From: Selim [mailto:Selim@sawayaeng.com]
Sent: Tuesday, June 18, 2019 8:03 AM
To: 'Ron Dragoo'
Cc: 'SoK@rpvca.gov'; 'Jill Martin'; 'Ara Mihranian'; 'Scott Campbell'
Subject: 2019-06-18 # Tract 50666 # Request for Storm Drain Amendment

Re: **Request to use Forestall Canyon to convey off-site storm water in lieu of the proposed 60 inch Reinforced Concrete Pipe.**

EXHIBIT "A"
TRACT 50666
PRE-DEVELOPMENT
EXISTING STORM DRAIN

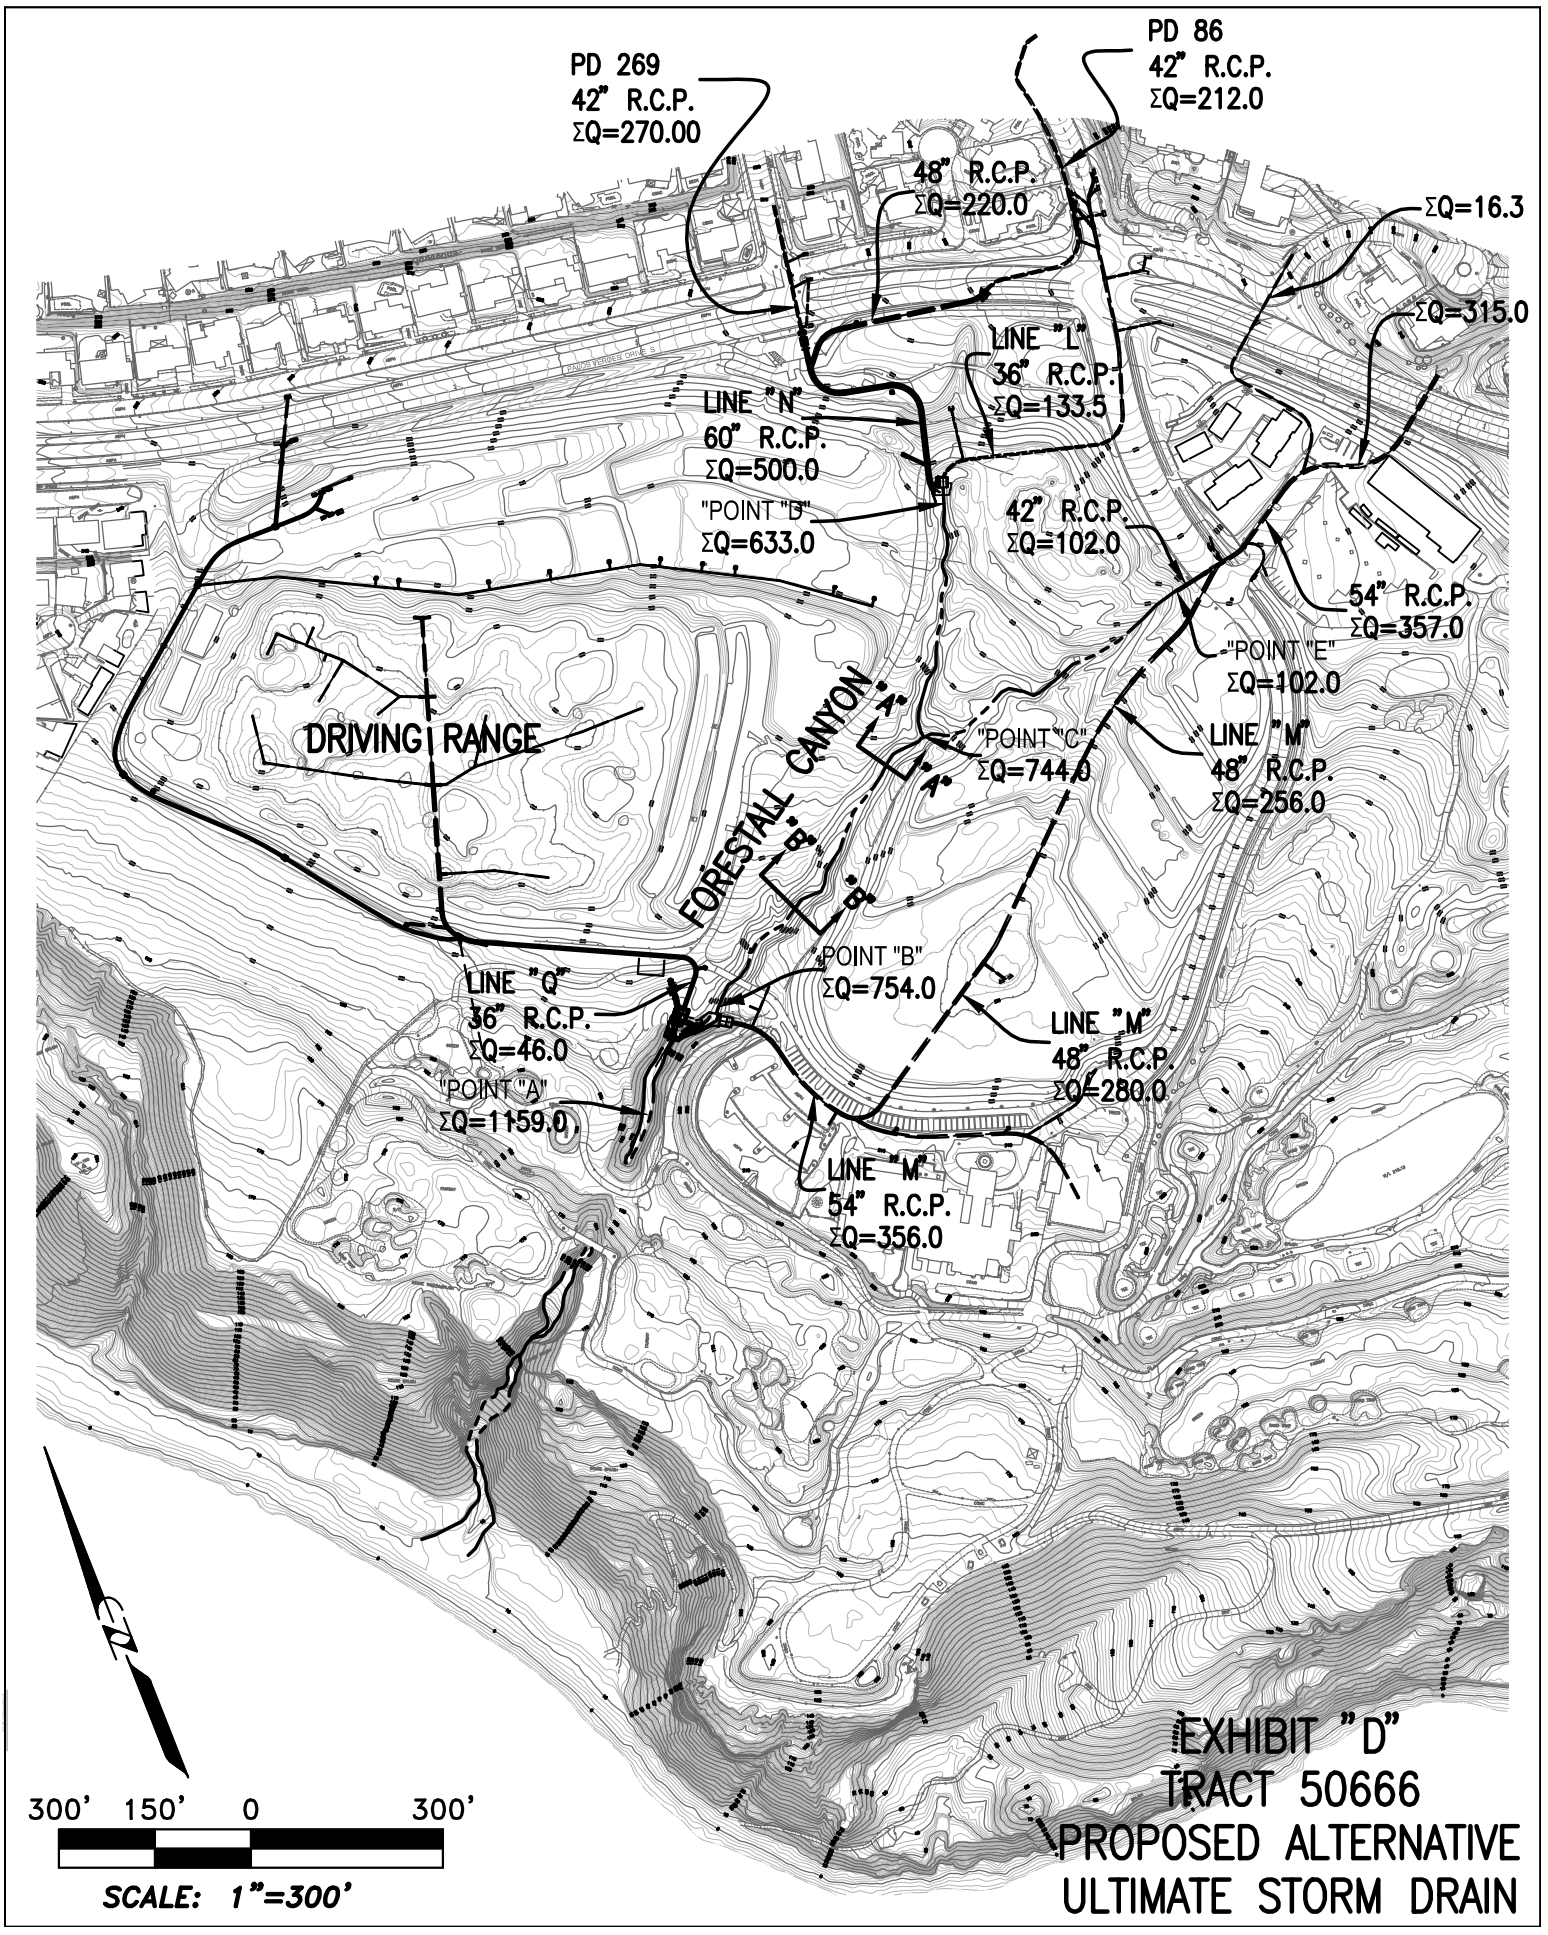
In 2005, an amended loting configuration for the site was approved and graded to provide for a driving range in lieu of 16 residential lots, thus reducing the number of residential lots west of Forestall Canyon from 29 to only 13 lots. The amended site as approved and graded has reduced and likely eliminated the risk of residential flooding from Forestall Canyon rendering the proposed Line "N" (60" RCP) redundant and unnecessary. Therefore, VH Property is requesting the City of Rancho Palos Verdes' approval to eliminate the portion of Line "N" that is adjacent to Forestall Canyon from Point "B" to Point "D".

1. The proposed ultimate flow of Forestall Canyon would be approximately 72% of historical (Predevelopment at Point "B" is 1050 cfs – Post development at Point "B" is 754 cfs).
2. The proposed ultimate flow of Forestall Canyon would be equal to the current/interim flow.
3. Forestall Canyon has performed well under the current/interim condition for the past 15 years.
4. No Residential lots would be at risk from flooding and high velocity scouring action.
5. Forestall Canyon has the capacity to carry the anticipated flow with a velocity less than 15 fps. (See Exhibit "E" for Hydraulic Calculation).
6. Since PD 86 and PD 269 are debris carrying line, Forestall Canyon is more suitable to carry the flow rather than a storm drain pipe.

7. The construction of Line "N" is very intrusive to the area due to its size (60") and depth (20').
8. Line "N" if constructed would be a debris carrying line with a pipe diameter of 60 inch at a minimum slope of 5%, carrying a flow of 549 cfs, resulting in a velocity of at least 38 fps. This would require a large outlet structure / riprap pad configuration which would be intrusive to the ecosystem of Forestall Canyon.
9. The Operator of the Golf Course is bound by a maintenance agreement with the City of Ranch Palos Verdes, which covers the extent of maintenance liability over Forestall Canyon and all outlet structures.

EXHIBIT "E"
TRACT 50666
PROPOSED ALTERNATIVE
HYDRAULIC CALCULATION

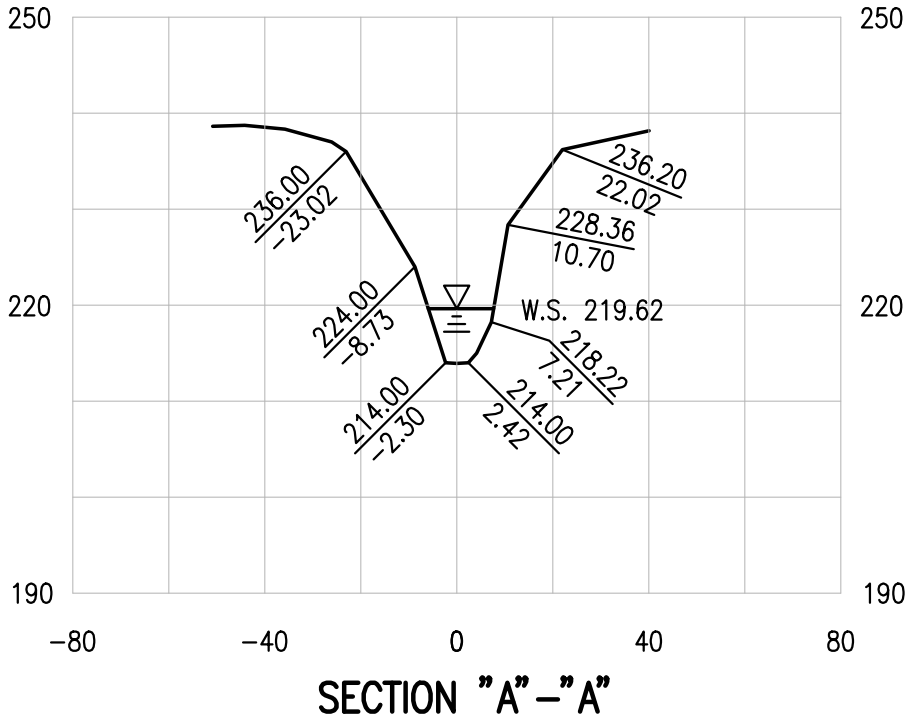
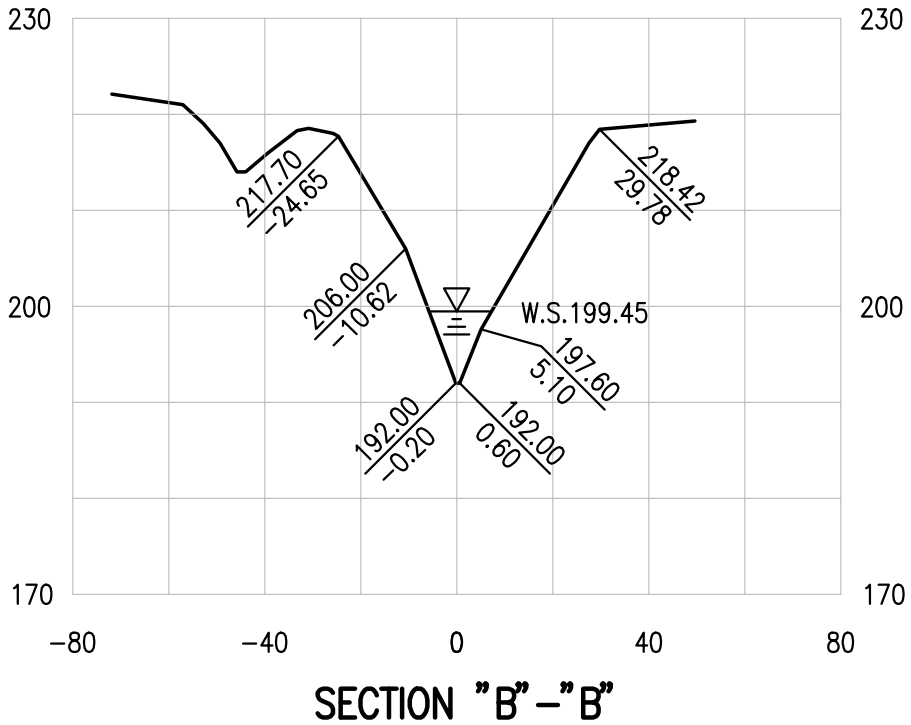
INPUT DATA
Channel Slope 0.043500 ft/ft
Elevation range: 214.00 ft to 236.20 ft.
Discharge 735.00 cfs

RESULTS
Wtd. Mannings Coefficient 0.045
Water Surface Elevation 219.62 ft
Flow Area 53.81 ft²
Wetted Perimeter 19.26 ft
Top Width 13.60 ft
Height 5.62 ft
Critical Depth 220.21 ft
Critical Slope 0.029653 ft/ft
Velocity 13.66 ft/s
Velocity Head 2.90 ft
Specific Energy 222.52 ft
Froude Number 1.21
Flow is supercritical.

INPUT DATA
Channel Slope 0.064000 ft/ft
Elevation range: 192.00 ft to 218.42 ft.
Discharge 754.00 cfs

RESULTS
Mannings Coefficient 0.045
Water Surface Elevation 199.45 ft
Flow Area 49.53 ft²
Wetted Perimeter 20.13 ft
Top Width 13.03 ft
Height 7.45 ft
Critical Depth 200.50 ft
Critical Slope 0.032121 ft/ft
Velocity 15.22 ft/s
Velocity Head 3.60 ft
Specific Energy 203.05 ft
Froude Number 1.38
Flow is supercritical.
